**PERMITTEE FLORENCE COPPER, INC.’s RESPONSE TO PETITION FOR REVIEW  
FILED BY THE GILA RIVER INDIAN COMMUNITY**

**Gila River Indian Community’s (“GRIC’s”) Comments on Draft Permit**

Re: Gila River Indian Community Comments on the Draft Class III  
Underground Injection Control Area Permit for the Proposed Florence Copper  
Project, Florence Copper Project Production Testing Facility, Florence, Pinal  
County, Arizona

**Subject: Florence Copper Project – Technical Aspects of the EPA Underground Injection Control Well Permit**

Figure 2 - BHP Pilot Test Wells and MODFLOW Grid Used to Simulate Flow and Particle Tracking

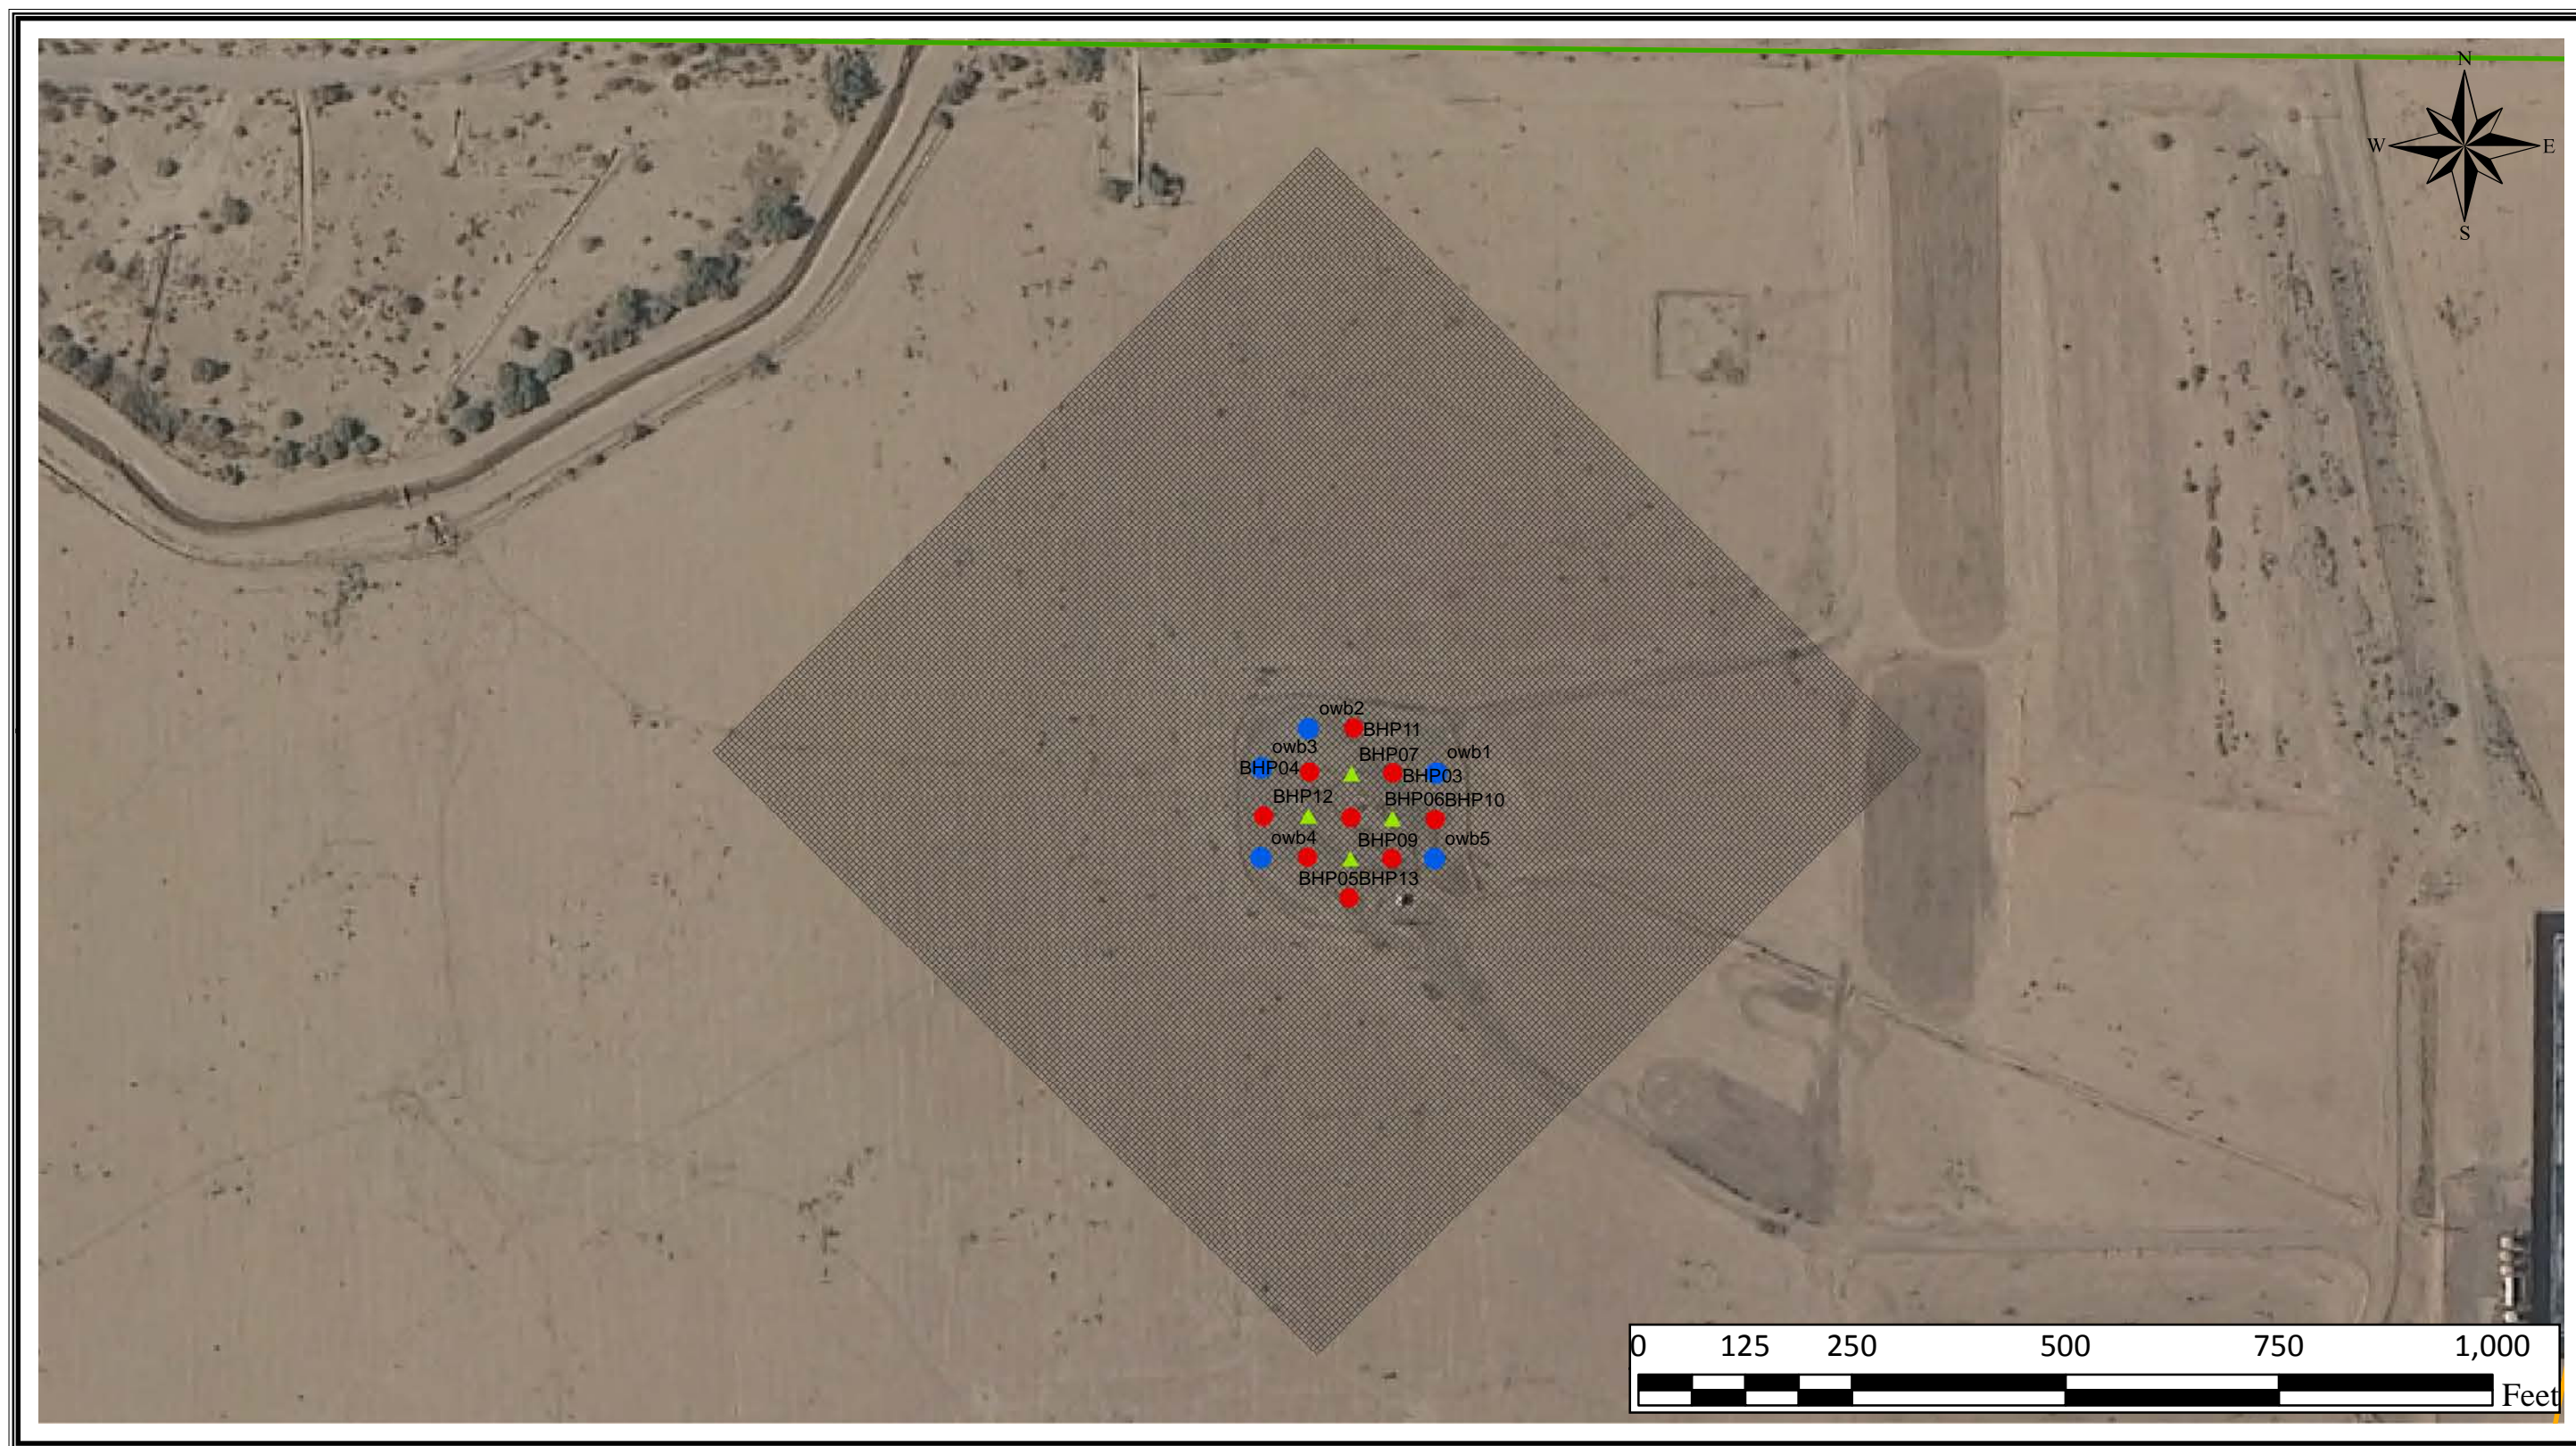
I developed a similar MODFLOW2005 model (same 1000 foot by 1000 foot area, but uniform 6.25-foot square cells) and used it to simulate water levels and the paths of water particles in the top half of the ore deposit starting from the injection wells. See Figure 2 for location of grid for this MODFLOW Model. I did not include the overlying basin fill aquifers in this initial modeling. Water leaking down from these aquifers would lead to less drawdown due to pumping at extraction wells than simulated here and therefore the potential for escape between extraction wells found here would be increased.

I imposed a slope to the groundwater levels of 0.002 (two feet of drop for every 1000 feet of lateral distance) directed to the northwest based on the typical values interpreted from monitoring in the ore deposit reported in the Permit Applications.

Figure 3 - BHP Test Conditions - Uniform Hydraulic Conductivity - Particle Tracks

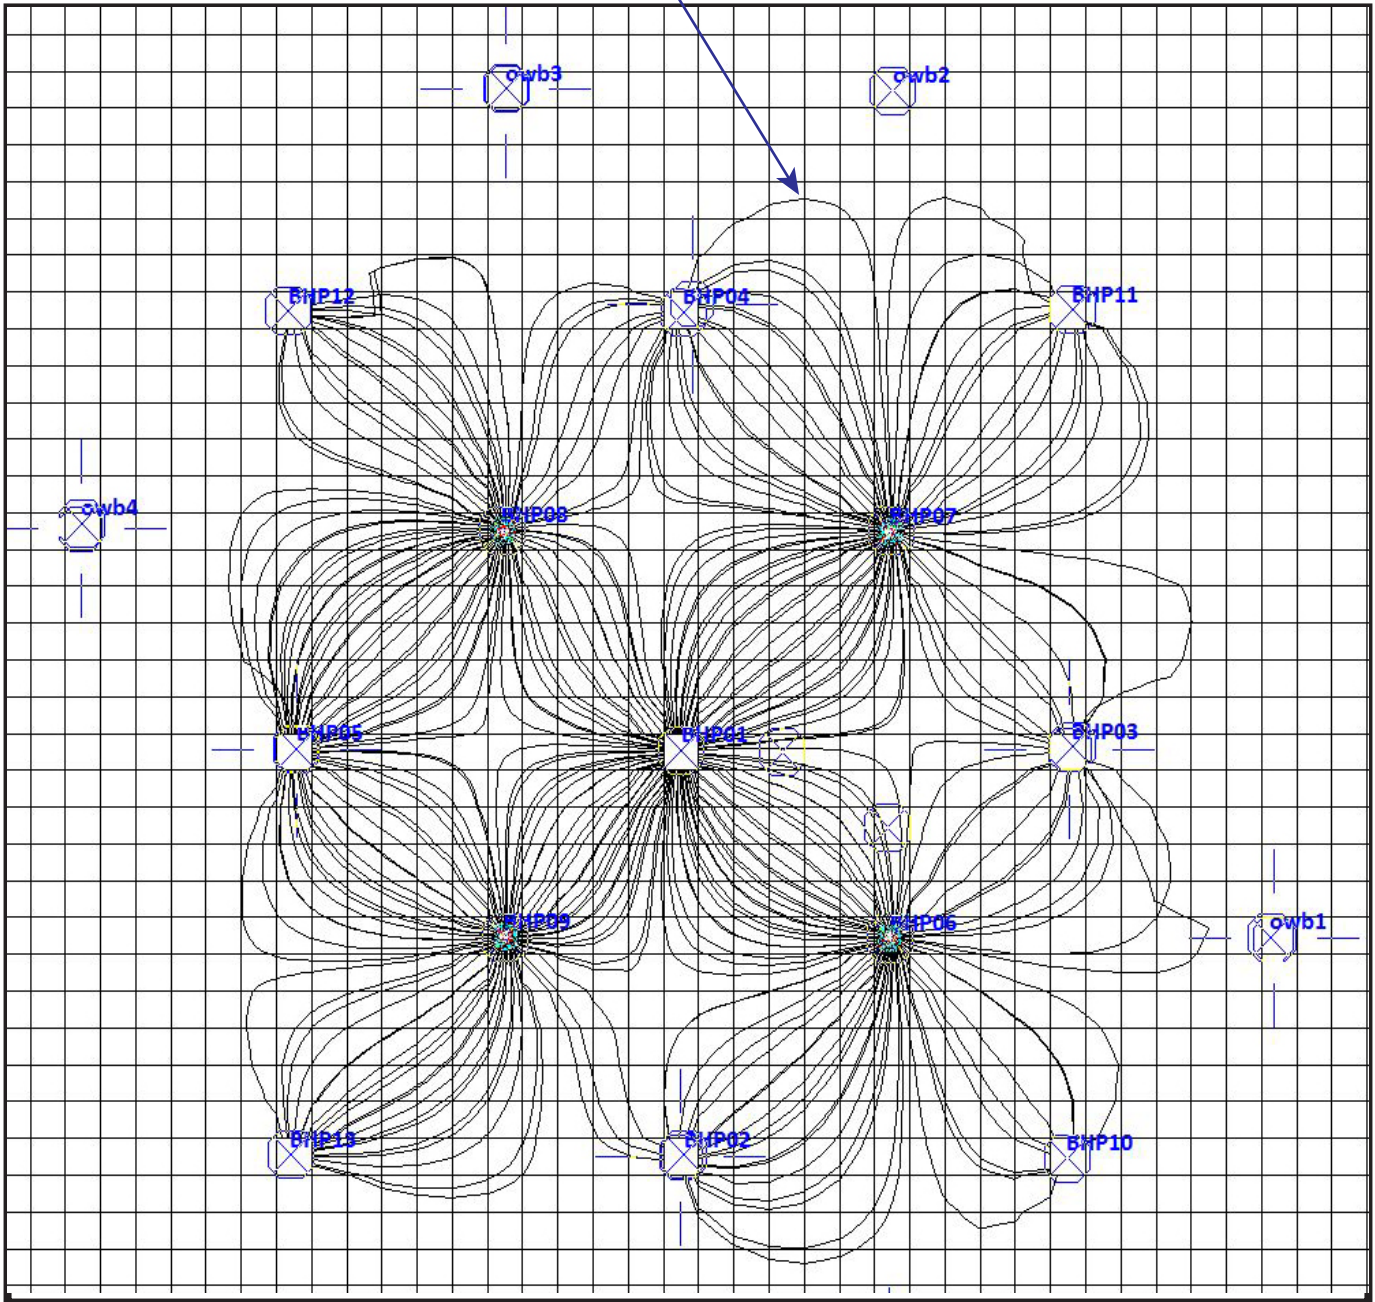
When a uniform value of K was used, the simulated tracks of particles indicate that particles starting at the injection wells can escape from between the enclosing extraction wells for the arrangement of pumping rates used during the BHP operations. However, the pumping pulls such particles back into the extraction wells. See Figure 3 for the simulated particle tracks resulting from the case of using a uniform K to simulate the BHP operations.

Particle Track escapes  
between extraction wells  
but is pulled back

**Figure 4 - BHP Test Conditions - Variable/Calibrated Hydraulic Conductivity Particle Tracks**

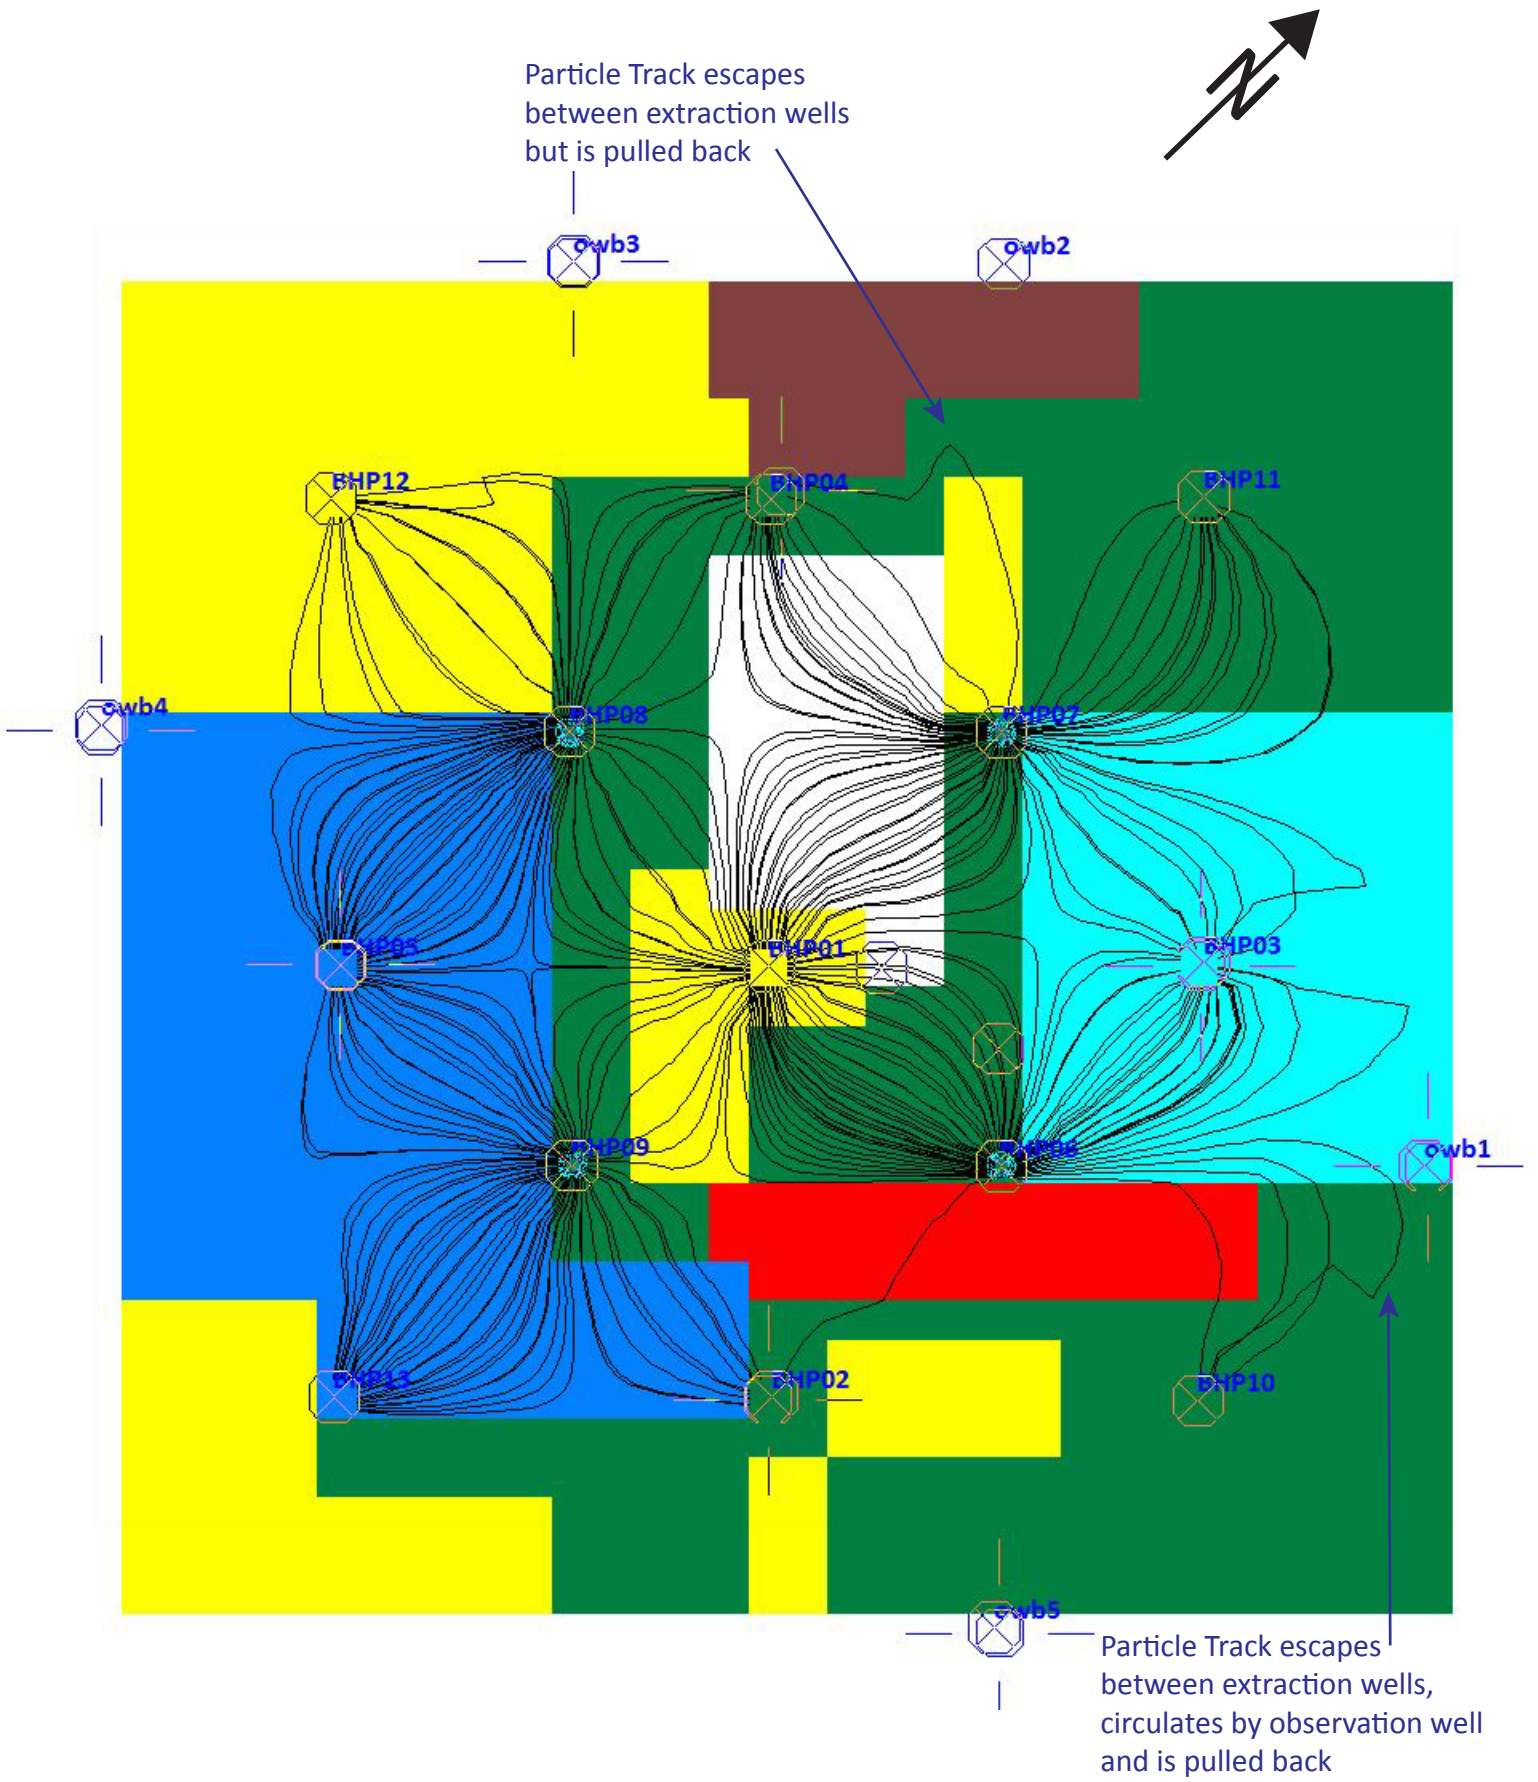
When the calibrated K distribution presented by BHP was used, similar results were found; though there was concentrating and spreading of the particle paths caused by heterogeneity between the injection and extraction wells. See Figure 4 for the simulated particle tracks resulting from the case of using the variable, zoned K distribution from BHP to simulate the BHP operations.

Figure 5 - BHP Test Conditions - Streak in Hydraulic Conductivity - Particle Tracks

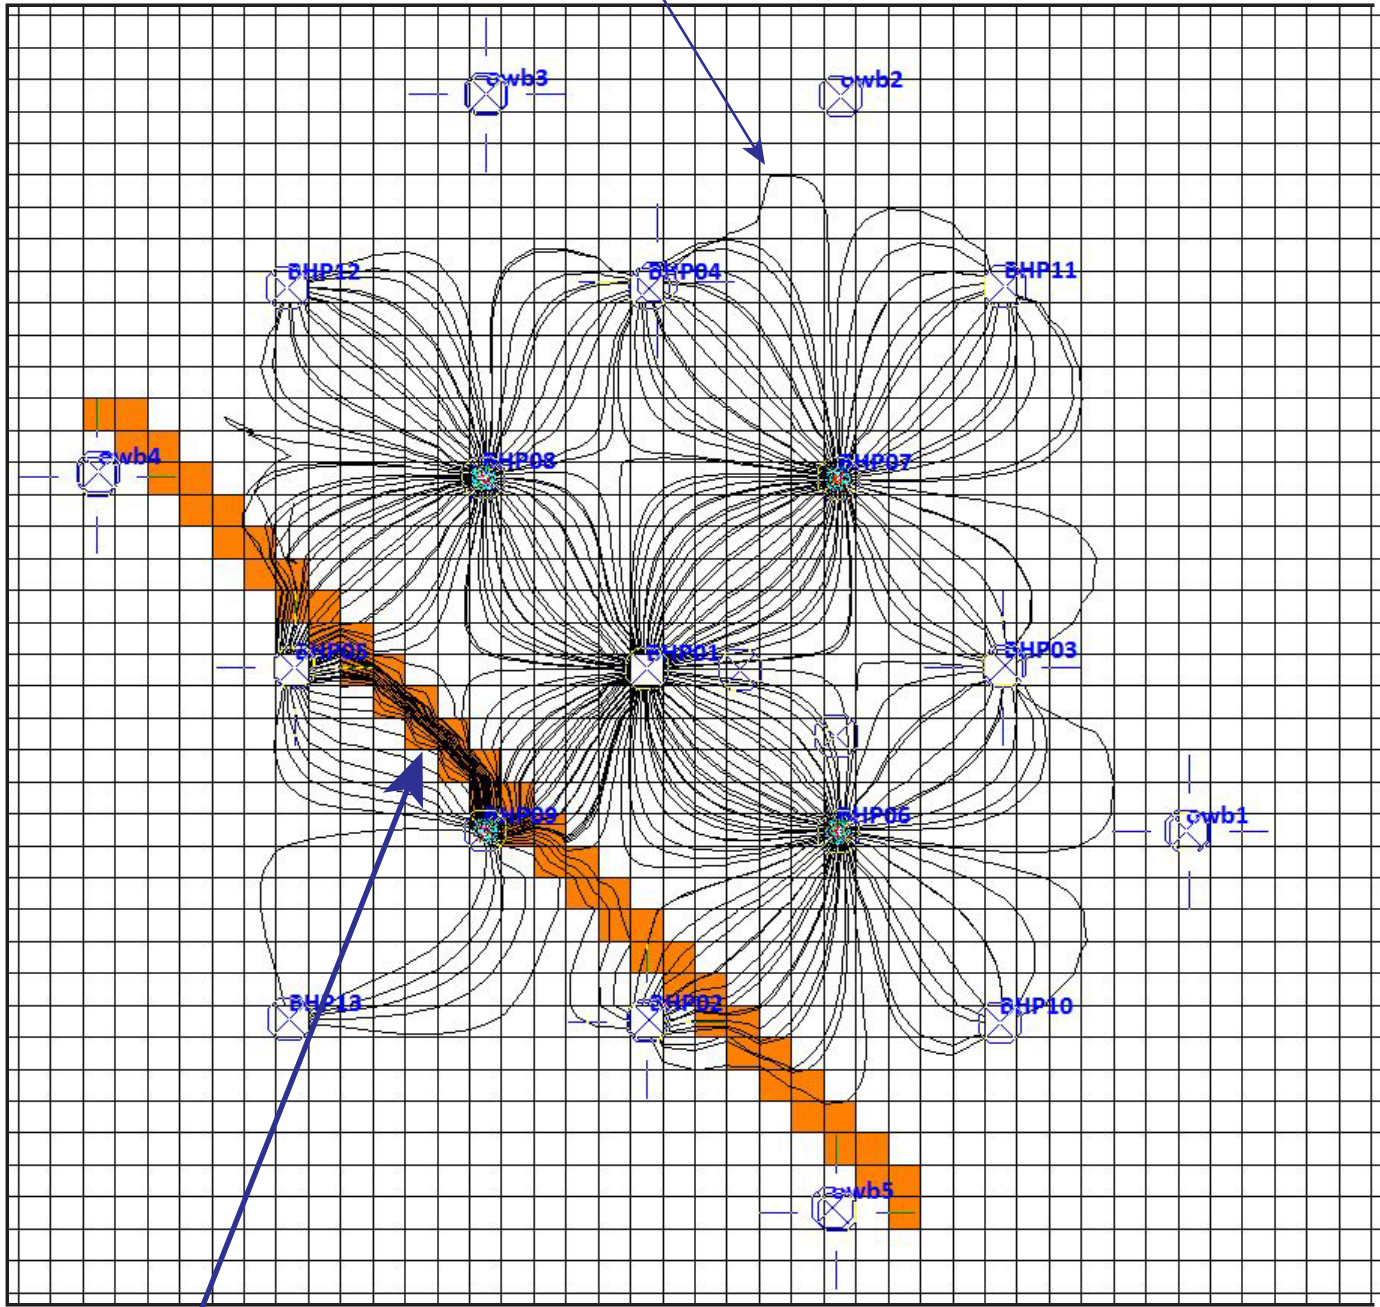
When the streak of high K also presented by BHP was used, the short circuiting between wells BHP 5 and BHP 9 simply concentrated nearby particle paths into the streak. This is a more pronounced version of the effect of heterogeneity also seen in parts of the calibrated K distribution results. The results were similar regarding the escape and recapture as noted for the other two cases. See Figure 5 for the simulated particle tracks resulting from the case of using the streak of high K from BHP to simulate the BHP operations.

Particle Track escapes  
between extraction wells  
but is pulled back

Streak of  $K = 9.7 \text{ ft/d}$   
Note channeling between wells
